**Proposed Coffee Drive-Thru Development,
Mannaberg Way, Scunthorpe**

Stage 1/2 Road Safety Audit

November 2020

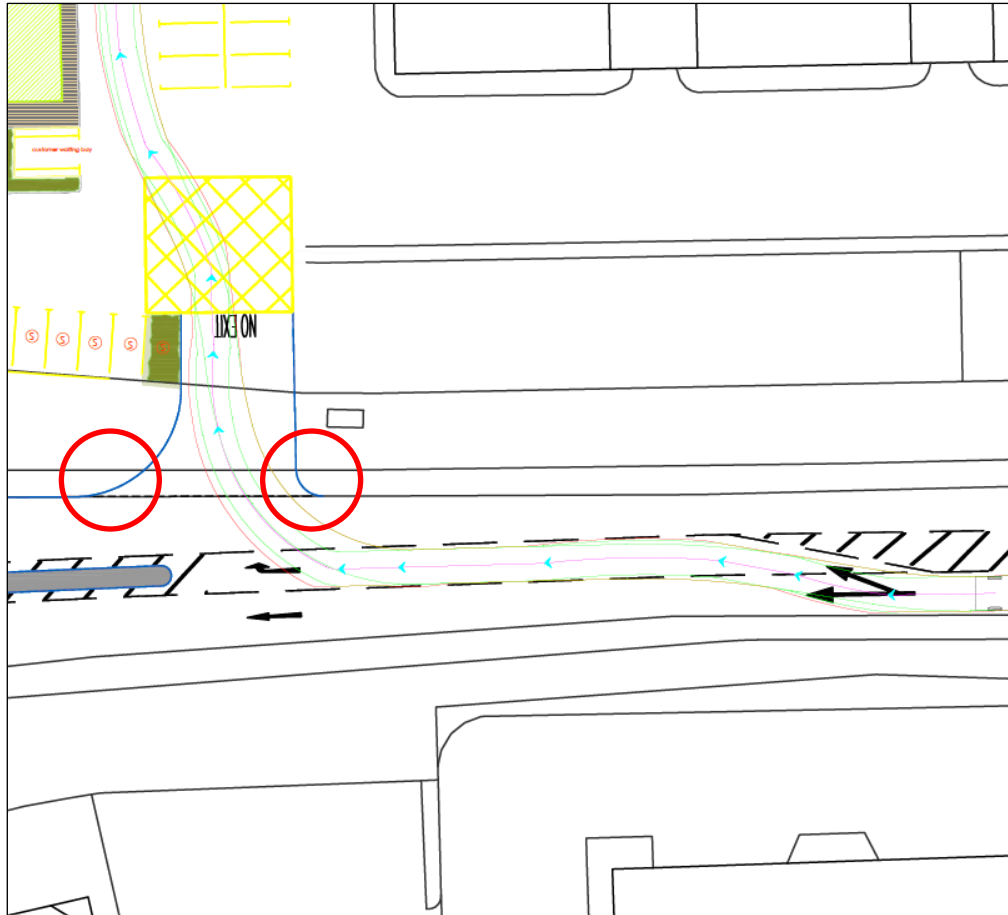
Location: Mannaberg Way

Summary: Bus stops on Mannaberg Way too close to site entrance and proposed central island

On Mannaberg Way there is an eastbound bus stop which will be very close to the proposed site entrance. There is a possibility that a stationary bus could overhang the site entrance and any vehicles turning into the site, particularly right turners, could come into contact with the bus, risking injury to vehicle occupants. The westbound stop on the southern side is also close to the proposed splitter island, and any overtaking vehicles could come into conflict with the island or be mistaken for a right turn movement into the access, increasing the potential for shunt type collisions.

It is recommended that the bus stops are moved further east from the entrance so that it is kept clear when a bus is stationary at the stop.

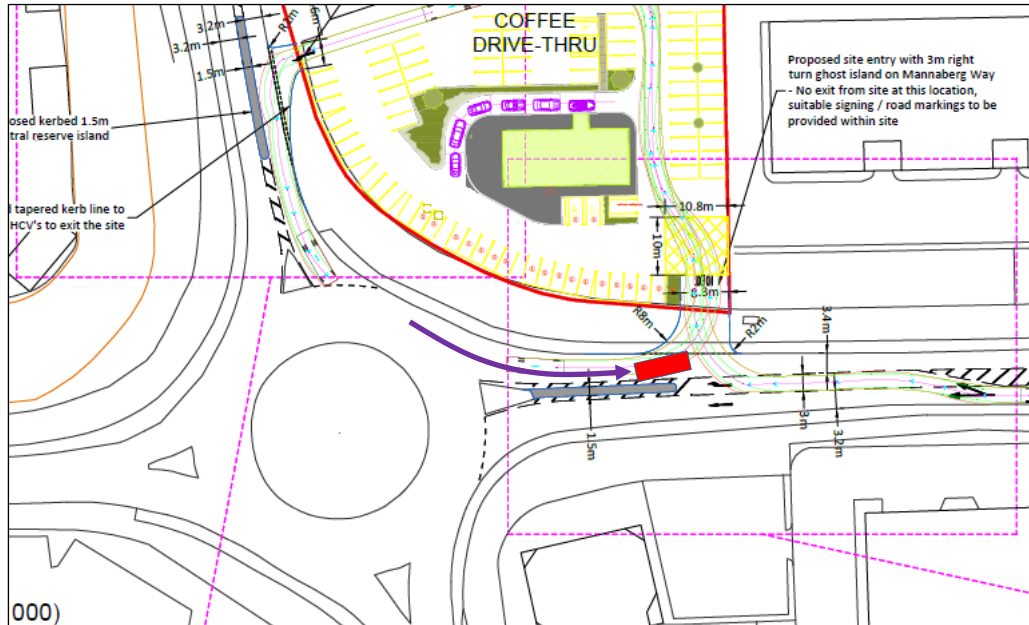
Location: Site entrance on Mannaberg Way

Summary: Lack of dropped kerbs and tactile paving

There are no dropped kerbs or tactile paving shown across the site entrance, which crosses a footway. Visually impaired pedestrians could trip and injure themselves over full kerbs when attempting to cross the entrance to the site without any dropped kerbs or tactile paving in place.

It is recommended that suitable dropped kerbs and tactile paving across the site entrance are provided.

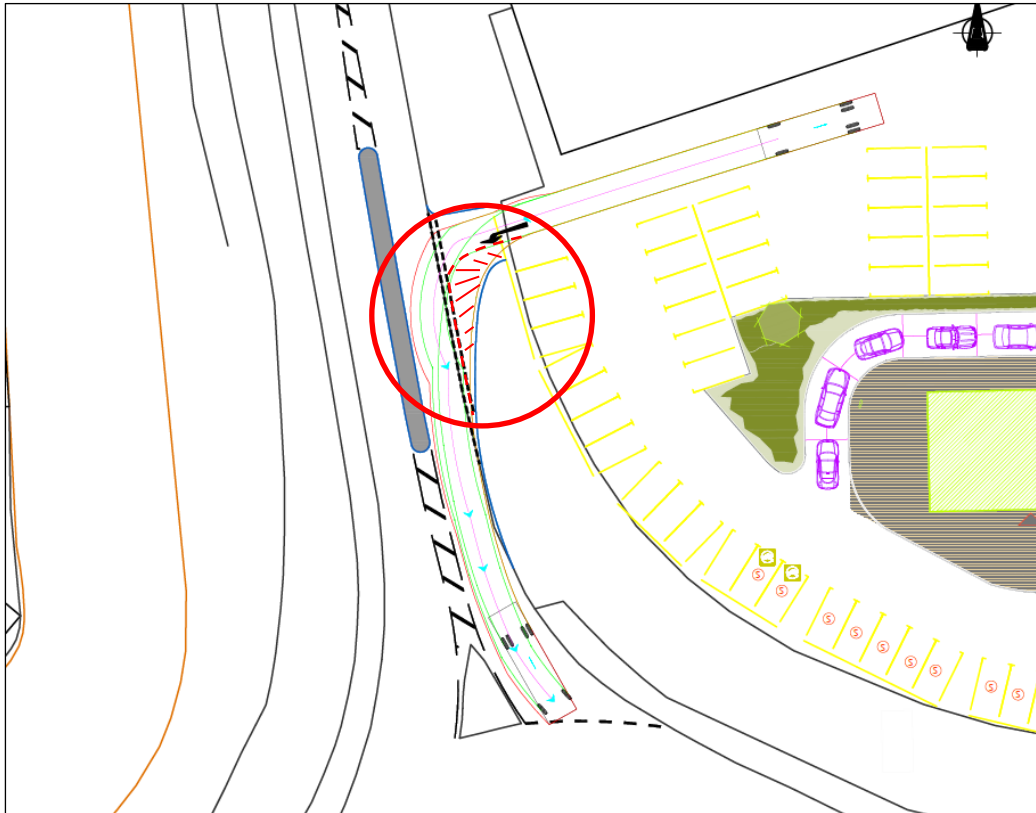
Location: Site entrance on Mannaberg Way

Summary: Conspicuity of proposed access

The proposed site entrance is located within an existing 40mph speed limit approx. 40m east of the Normanby Road roundabout. Any hesitancy or late braking amongst vehicles turning left into the proposed access could increase the risk of shunt type collisions as vehicles exit the roundabout.

It is recommended that the scheme designer assesses the conspicuity of the access for approaching drivers prior to any S278 application and, if deemed necessary, that further measures are implemented within the highway or within the site to, as far as practicable, reduce the risk of shunt type collisions. Examples of further measures could include warning signing, high performance surfacing, reduced speed limit, marker posts, or appropriate works/signing within the site boundary.
